MEMORANDUM

TO: District of Columbia Zoning Commission

FROM: *JLS*
Jennifer Steingasser, Deputy Director Development Review and Historic Preservation

SUBJECT: **Setdown Report** for ZC #15-14, DC Water – Consolidated Planned Unit Development with Related Map Amendment from the CG/W-2 to CG/CR

PLAZA & AUTOCOURT ILLUSTRATIVE

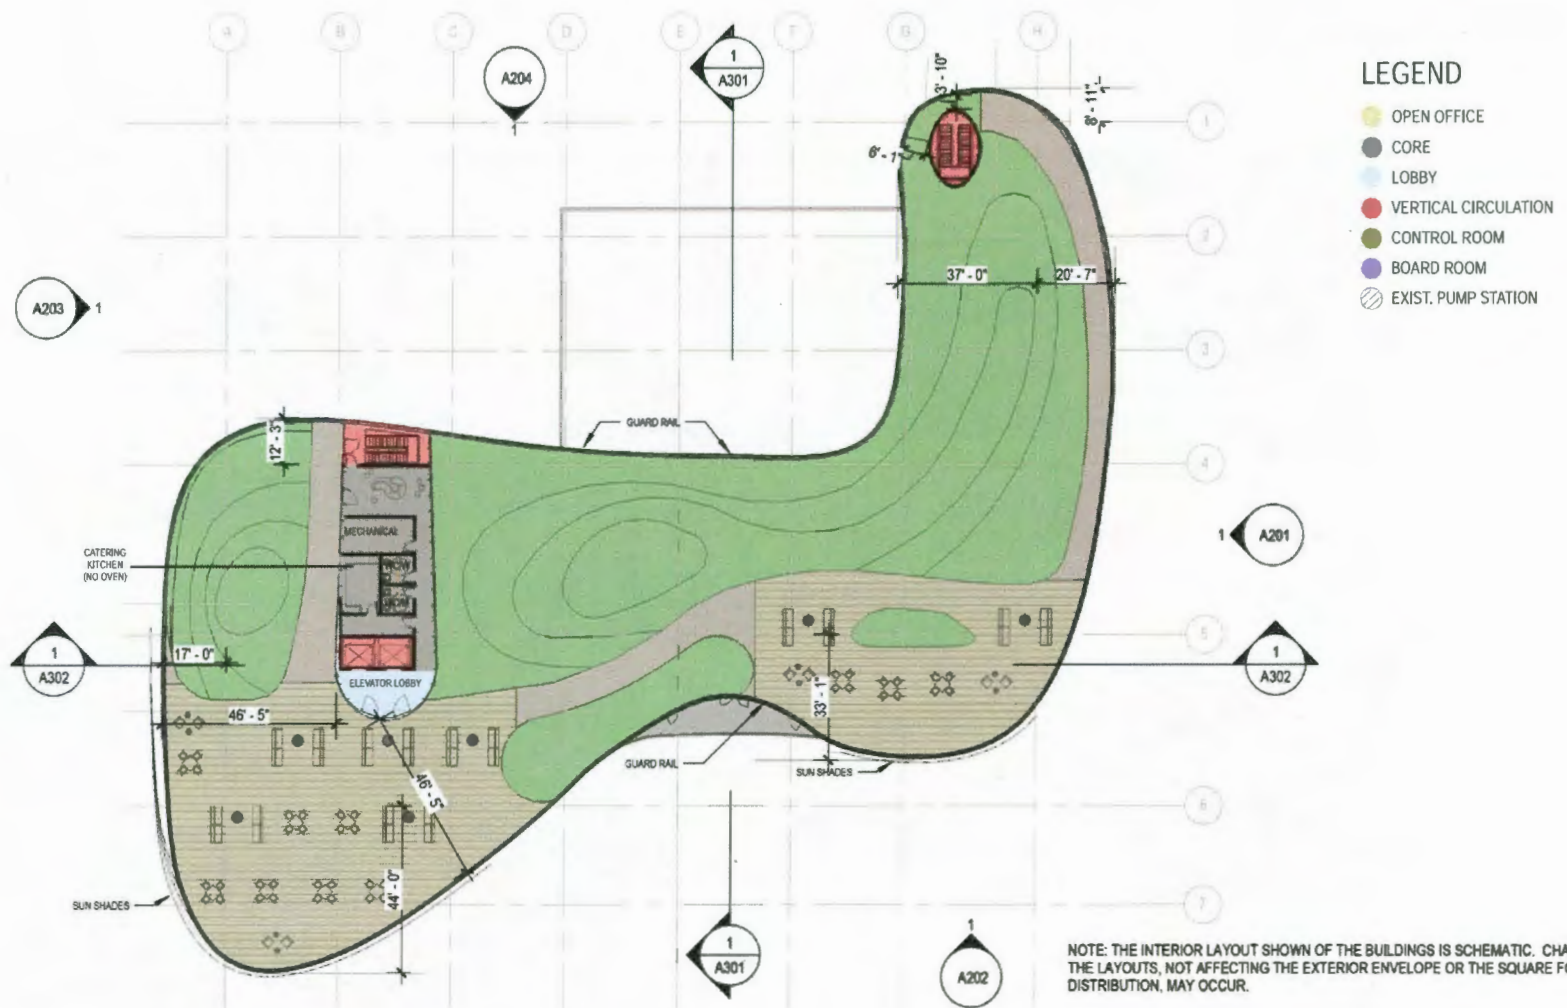
- two secure entrances: one at the northeast side at Canal Street and N Place and one on the west side at 1 ½ Street
- a concrete paver plaza and autocourt at east side of building (Sheet L.16 in Attachment 2)

ROOF PLAN

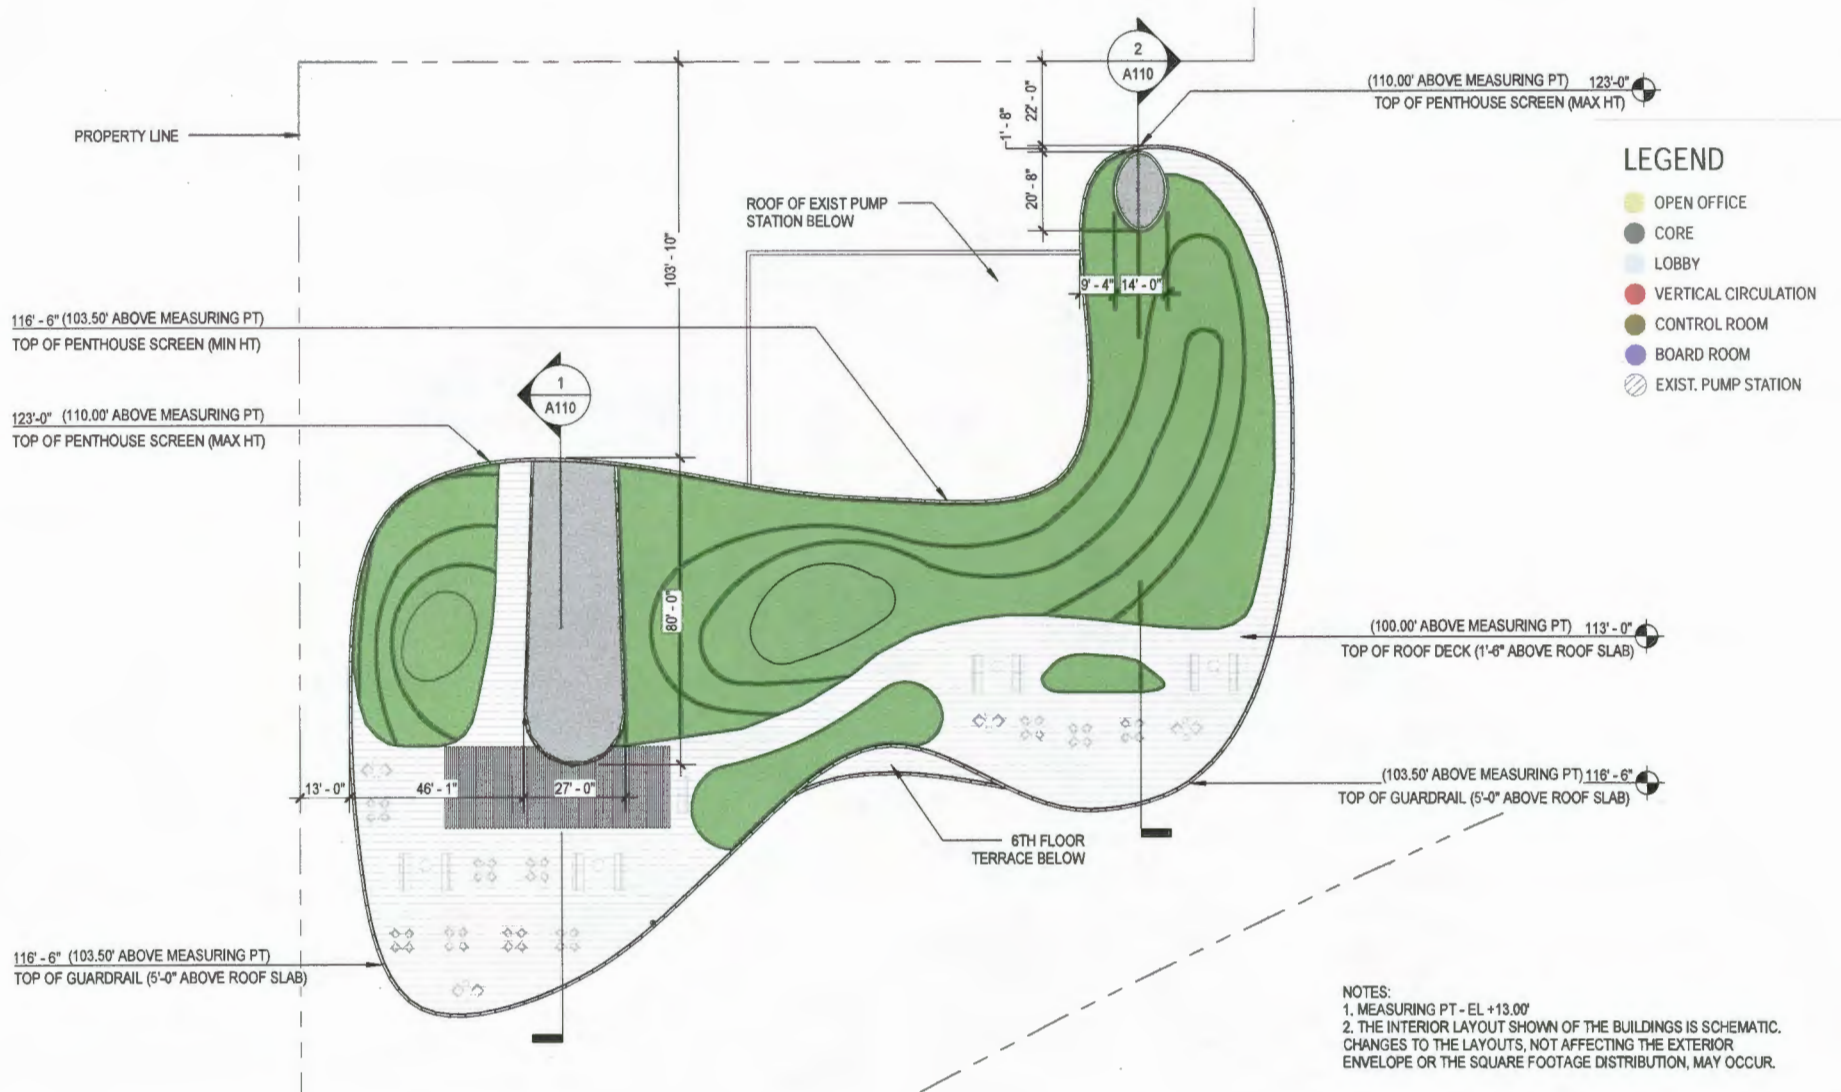
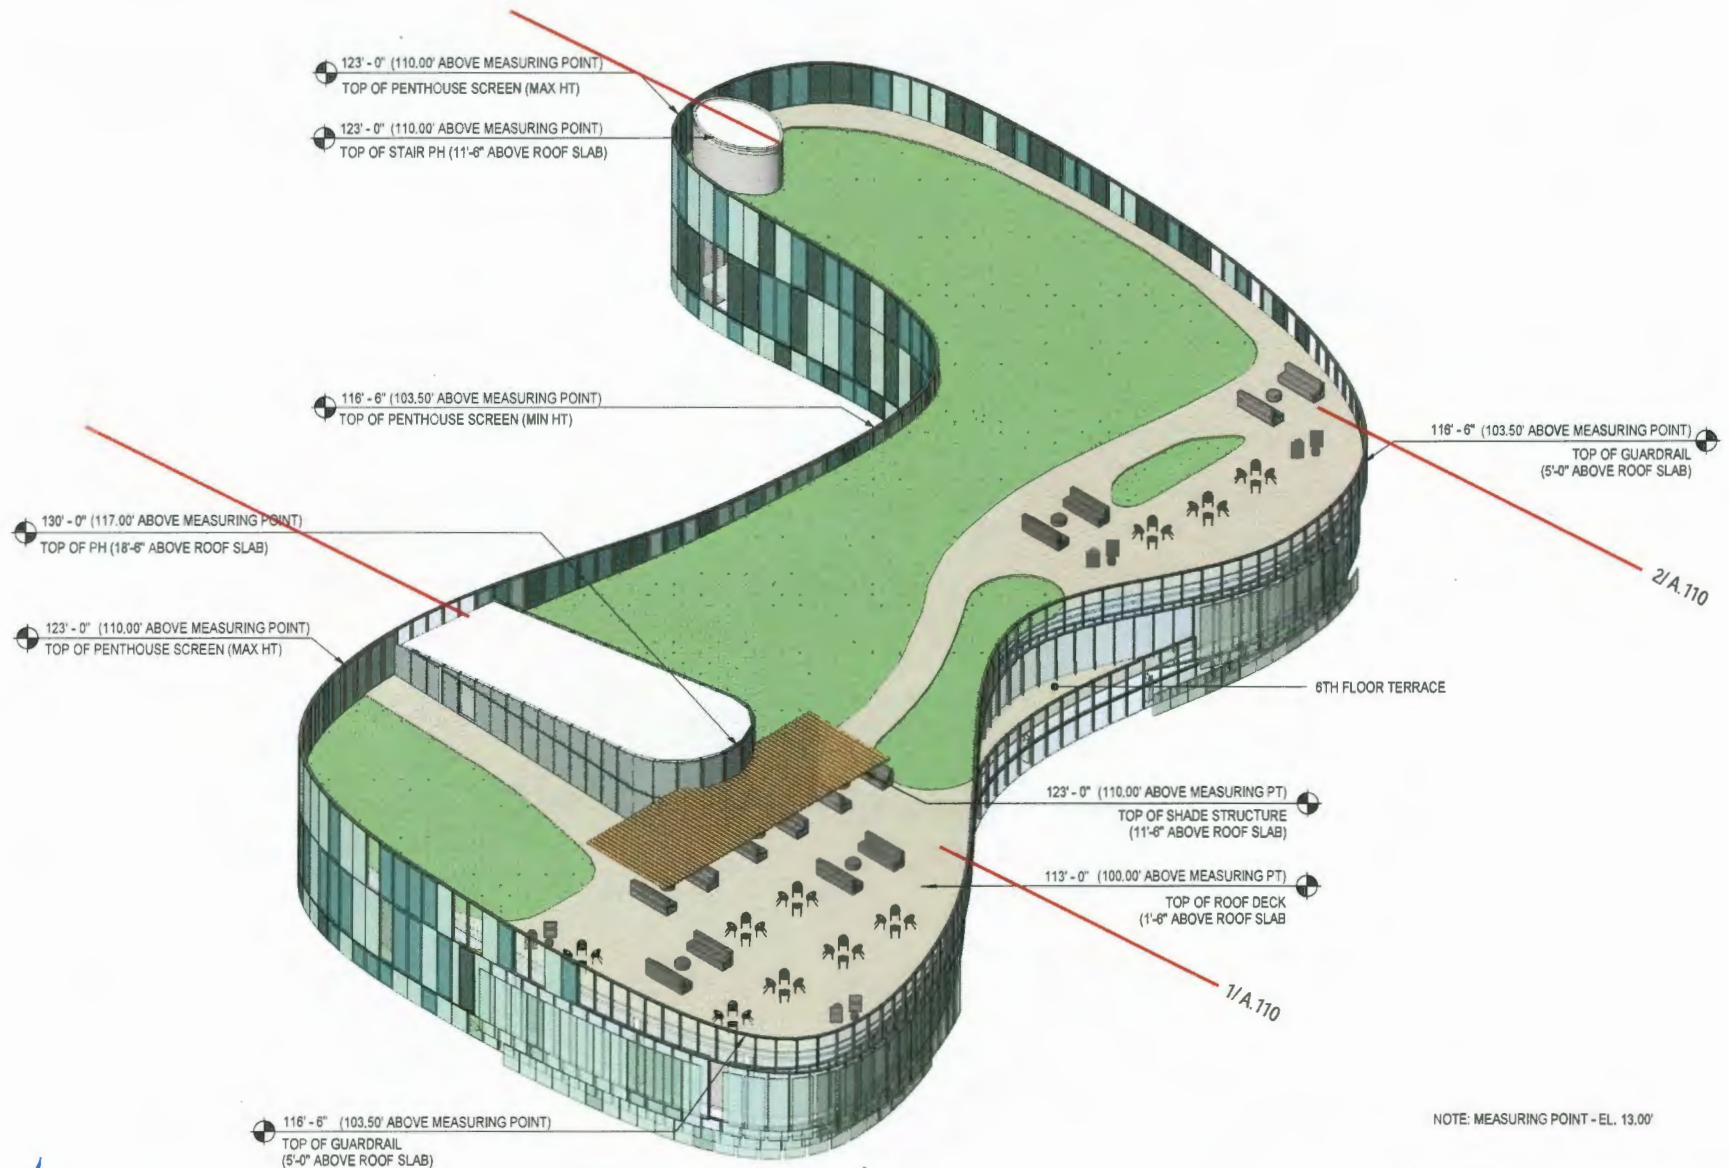
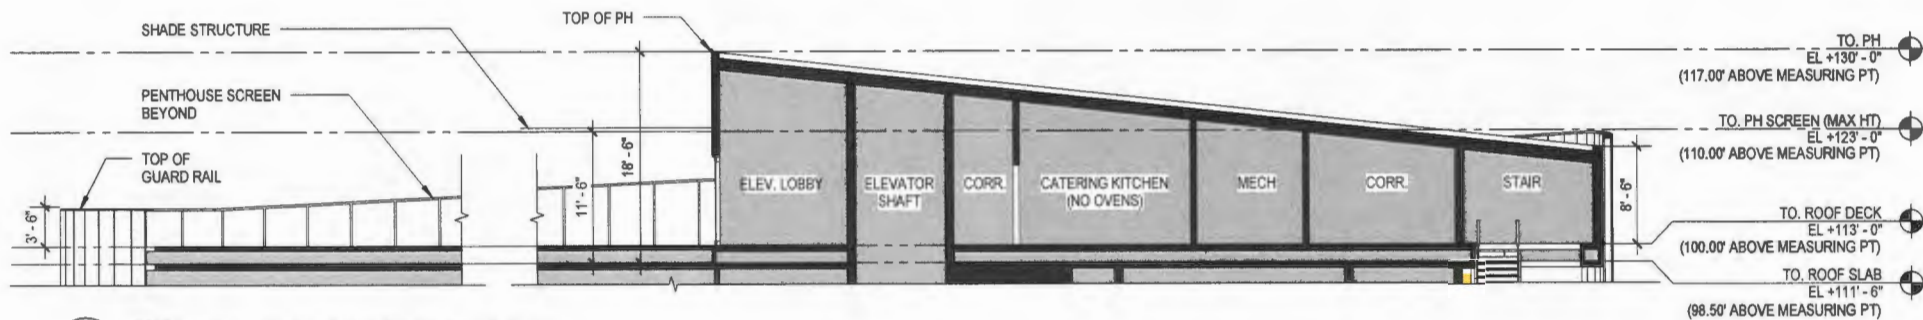
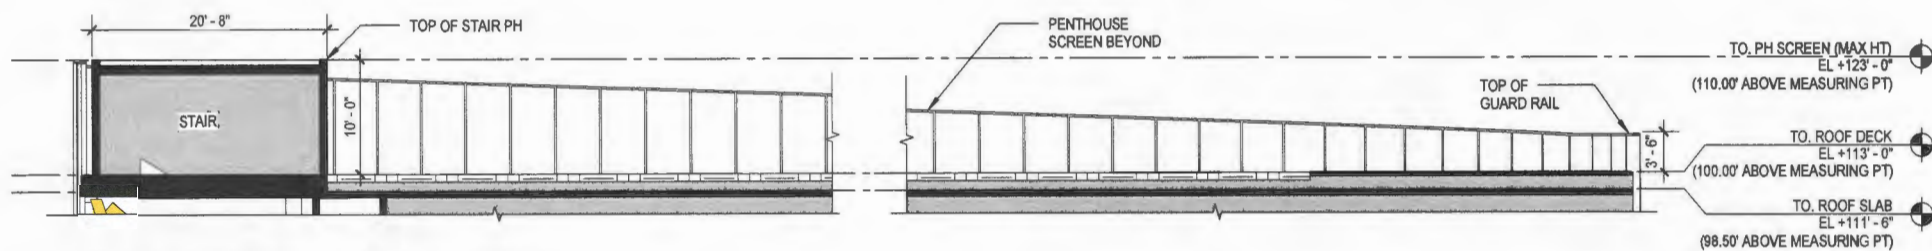
The proposed roof plan shows a mechanical penthouse, stairs, trellis, vegetated roof, and an angled penthouse screen (see detail in Sheets A.107, A.108, A.109 & A.110 in Attachment 2)

The applicant provided OP with additional plans as shown in Attachment 2 to assist in the review of the project, and OP is now requesting additional plans. OP is asking the applicant to provide renderings and perspectives to show how exactly the existing pumping station will be encapsulated and what that will look like as viewed from the west and north. OP also requests illustrations of the roof showing how it meets Code.

1. Structure: There is more than one structure on the roof
 2. Setback: The two roof structures are not set back at 1:1 distance from the surrounding walls

3. Height: The roof on the west side will have two heights due to elevator overrun

FENCE DIAGRAMS

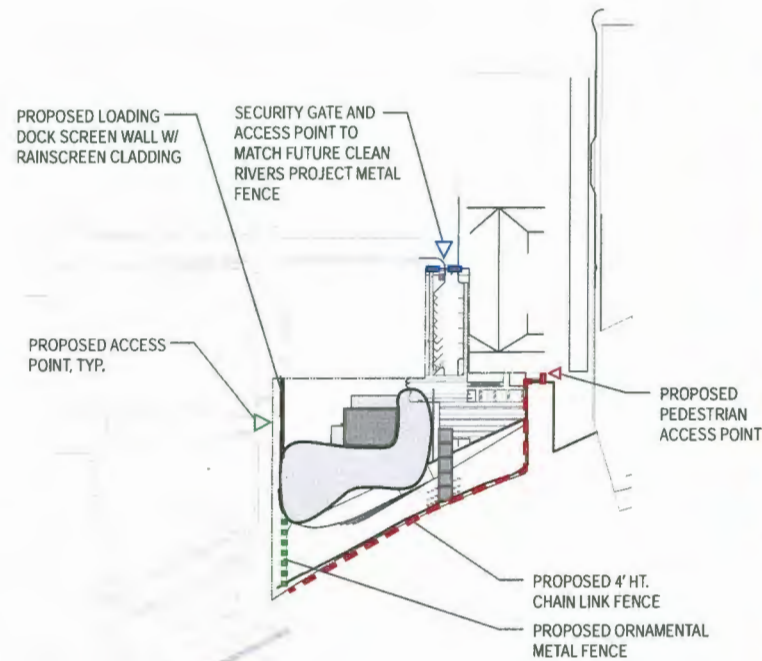
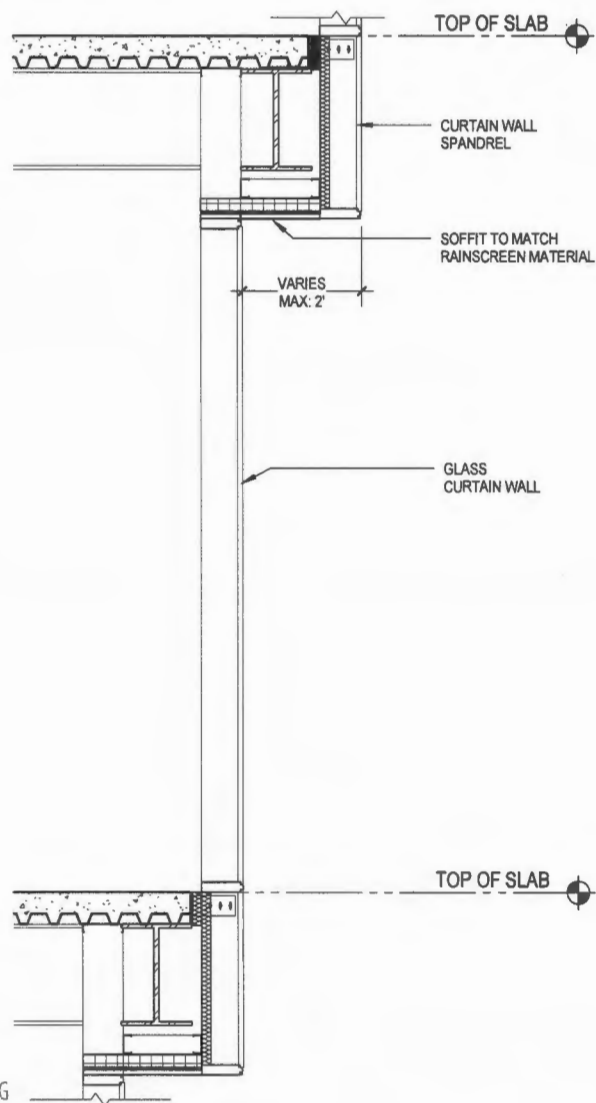
- three different materials proposed for fencing around the site: primarily chain link with one section of “Clean Rivers” open metal fencing at the northeast entrance and one section of ornamental metal fencing at the southwest side entrance; loading dock screen wall with rainscreen cladding (see Sheet L.15 in Attachment 2)

The proposed building will be distinctive and visible but the proposal shows the site surrounded almost entirely with chain link fencing. OP recommends that the applicant revise the plan to show “Clean Rivers” open metal fencing or some other continual fencing that is appropriate for this project. The fencing around this building should also be consistent with the fencing around the historic pumping station site.
